ADDENDUM NO. 2

Kau Water System Improvements – Phase 1

IFB No.: IFB-20-HHL-019

5 SECTION "Y-Y"
C-13 NOT TO SCALE

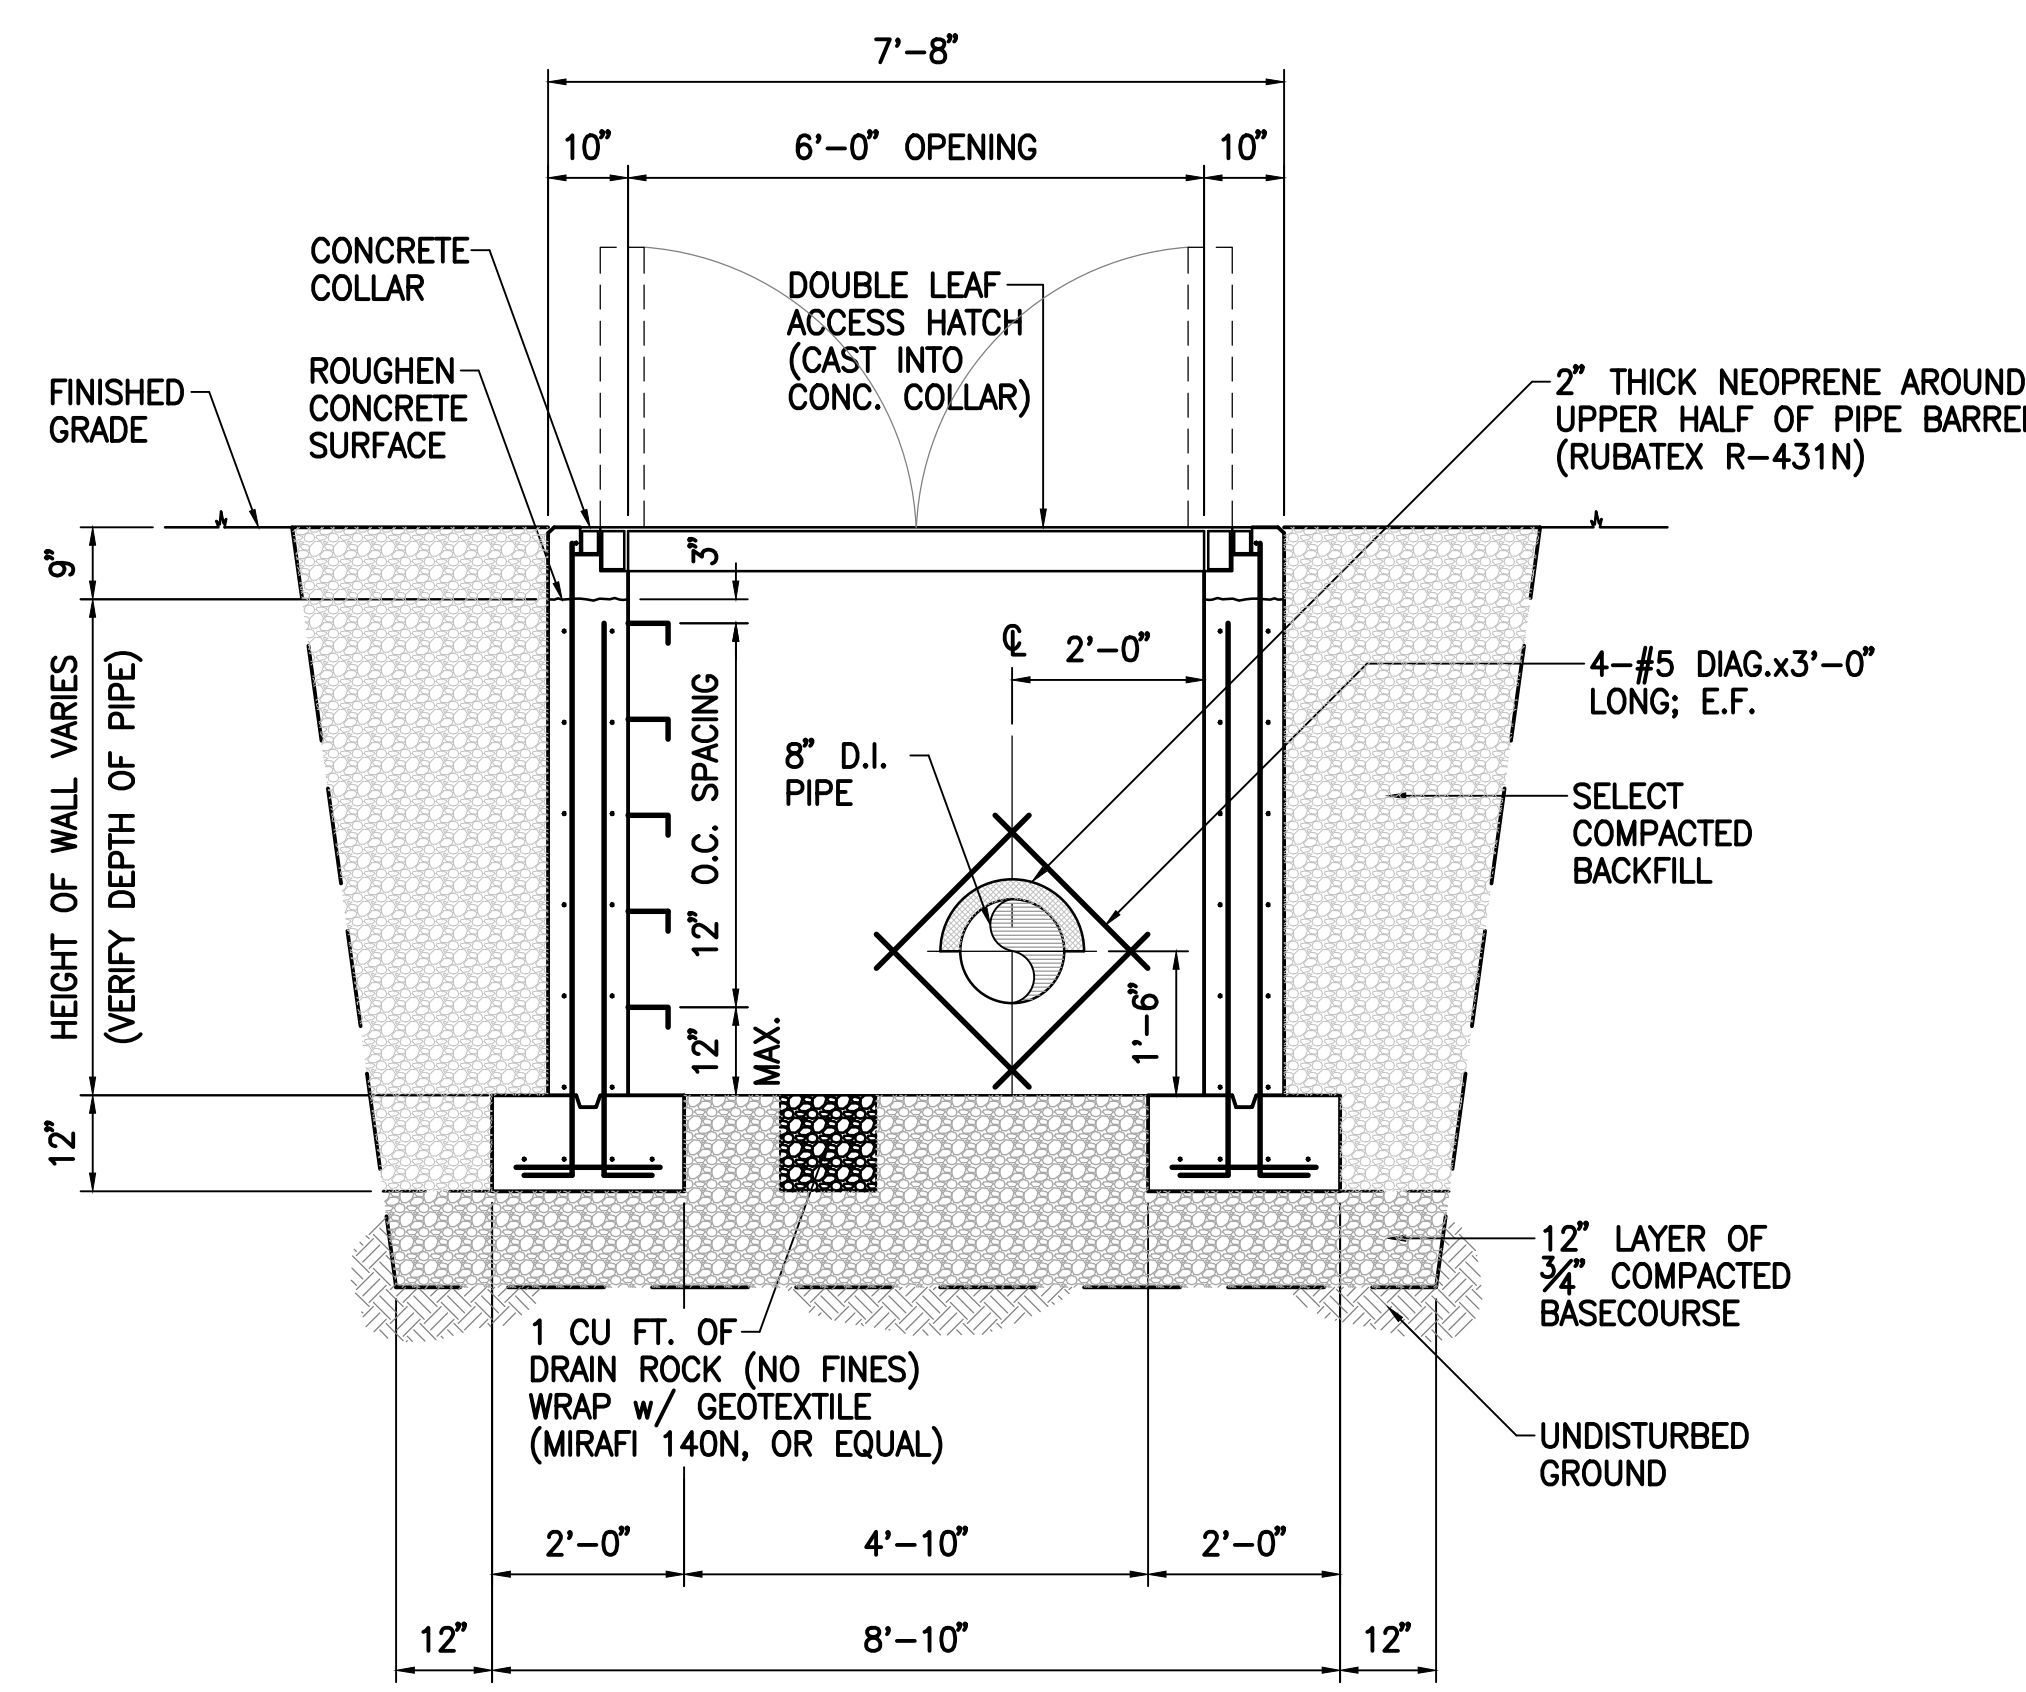
9. PLANS: Drawing No. C-13 - Revisions include deleting the Pipe Strap Detail for the 4-inch pipe and deleting the H-20 traffic rating for the flow meter vault access hatch.

1
S-5
DETAIL OF OVERFLOW PIPE
NOT TO SCALE

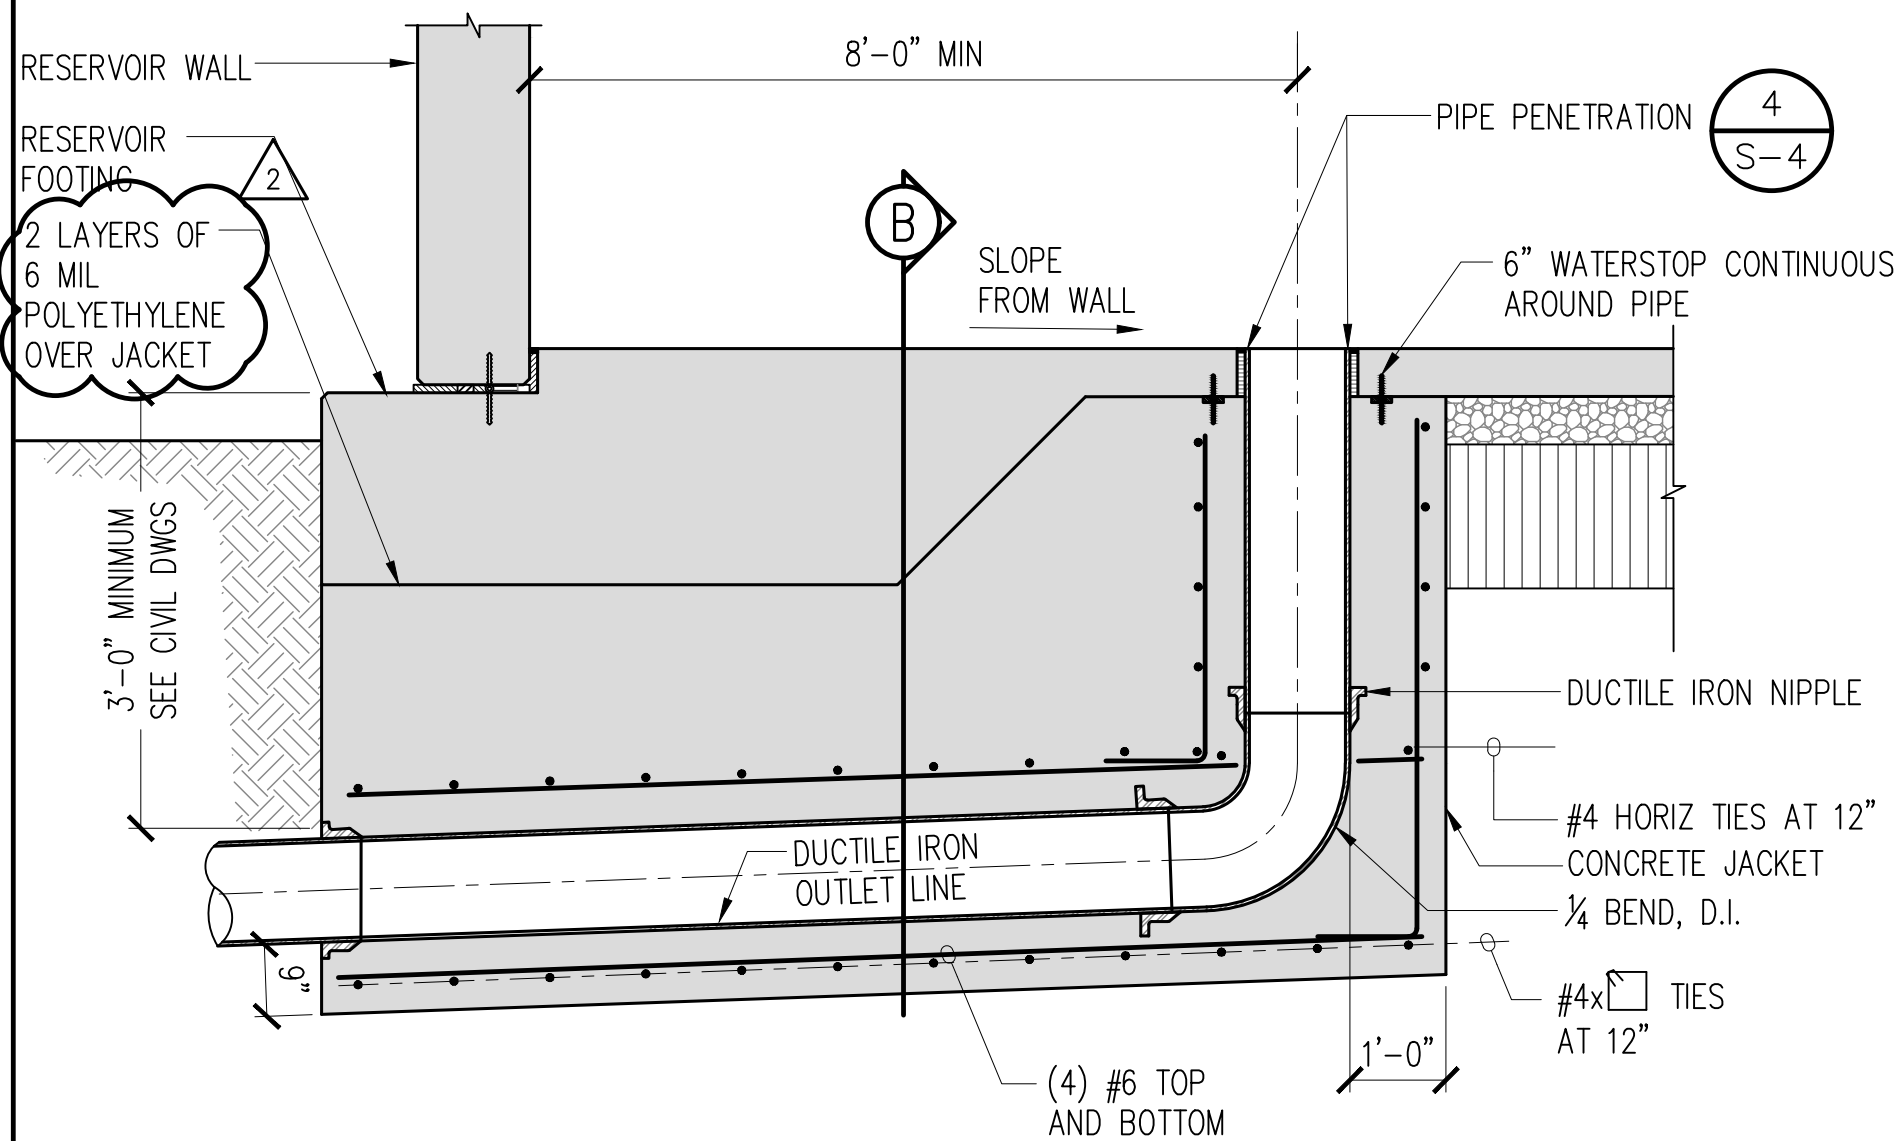
5. PLANS: DETAIL 1/S-4 – Revised perimeter drain layout of 6 mil poly liner, 30 mil membrane, and filter fabric.
6. PLANS: DETAIL 1/S-5 – Removed concrete pedestal from overflow pipe, and revised pipe through slab; replaced wording “Hot Asphalt Mop” from reservoir concrete footing and concrete jacket interface with revised wording “2 Layers of 6 mil Polyethylene Over Jacket”; added pipe coating to exposed overflow pipe.

3
S-5
EFFLUENT LINE (INFLUENT, SIM)
SCALE: 1/2" = 1'-0"

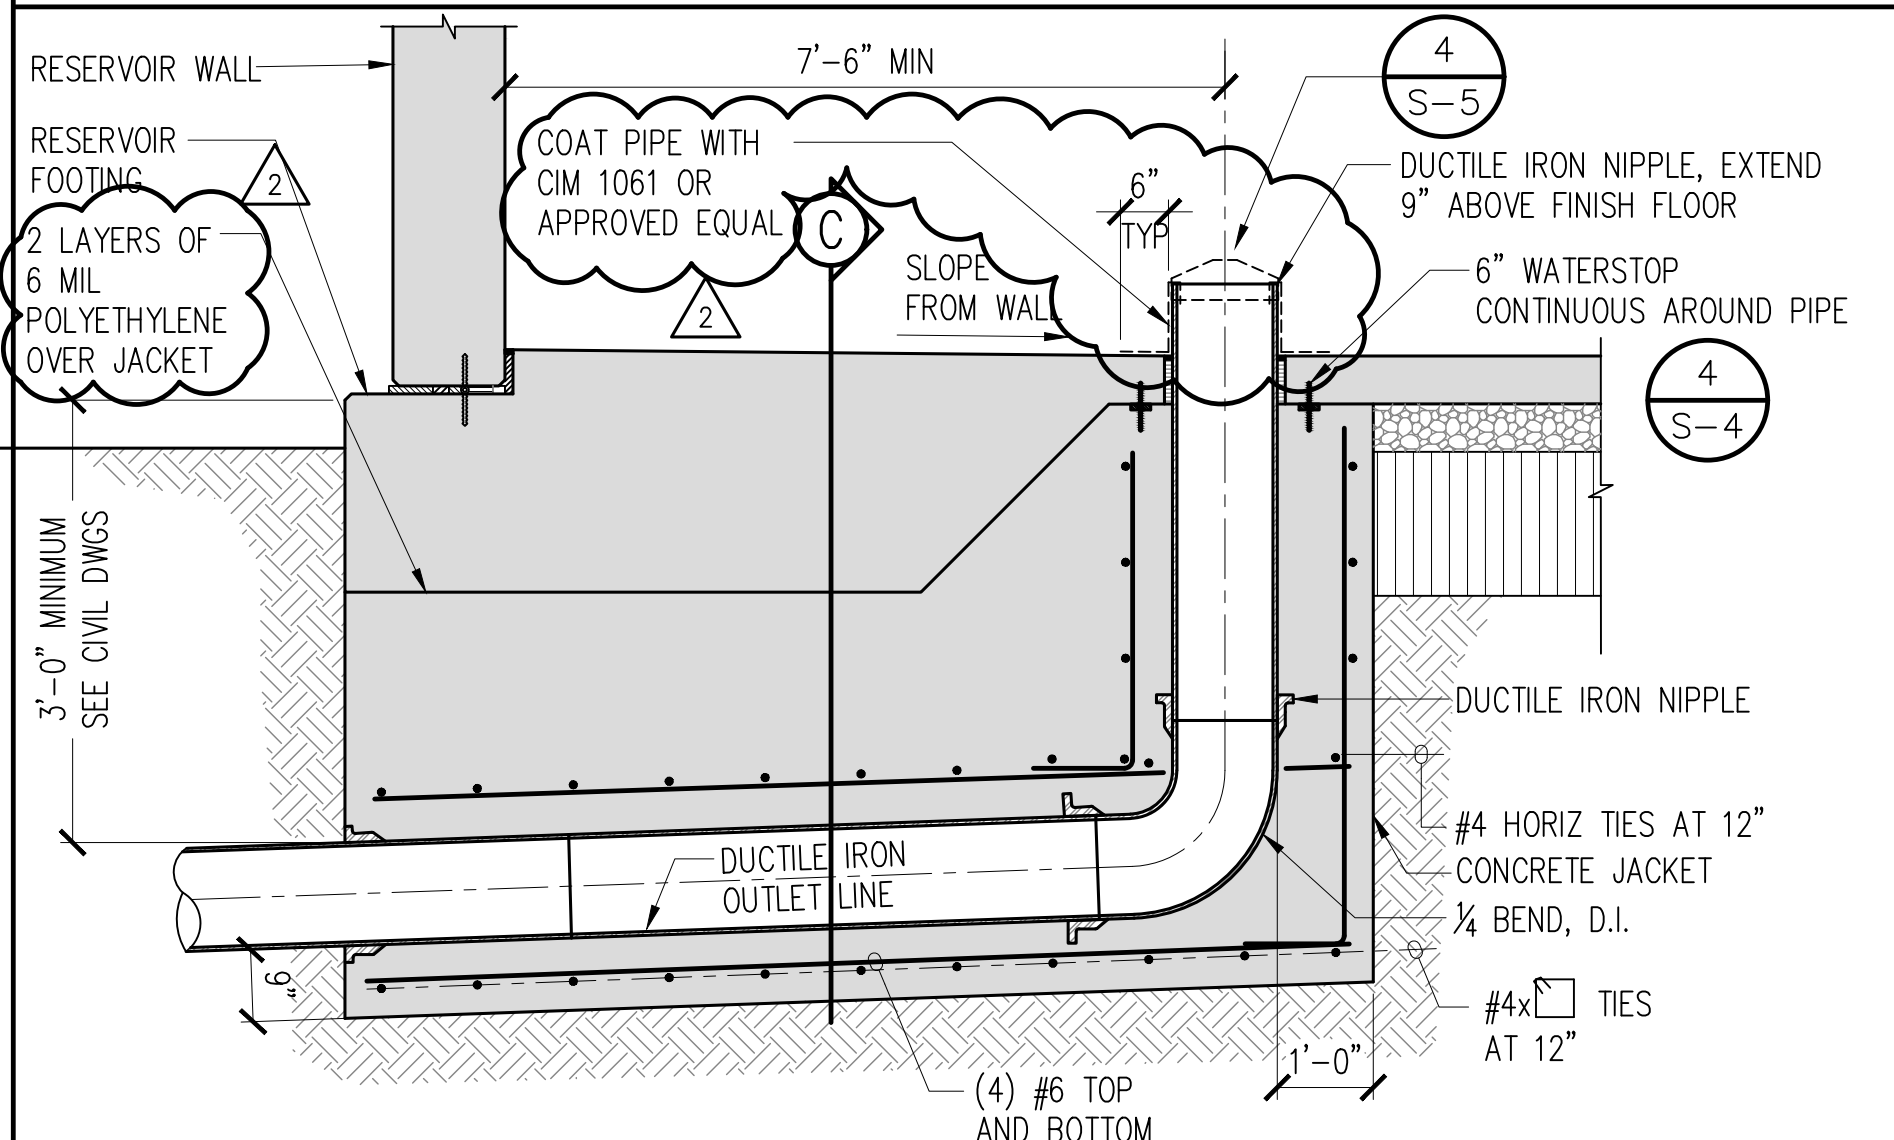
8. PLANS: DETAIL 3/S-5 – Replaced wording “Hot Asphalt Mop” from reservoir concrete footing and concrete jacket interface with revised wording “2 Layers of 6 mil Polyethylene Over Jacket”; added pipe coating to exposed effluent and influent pipes.
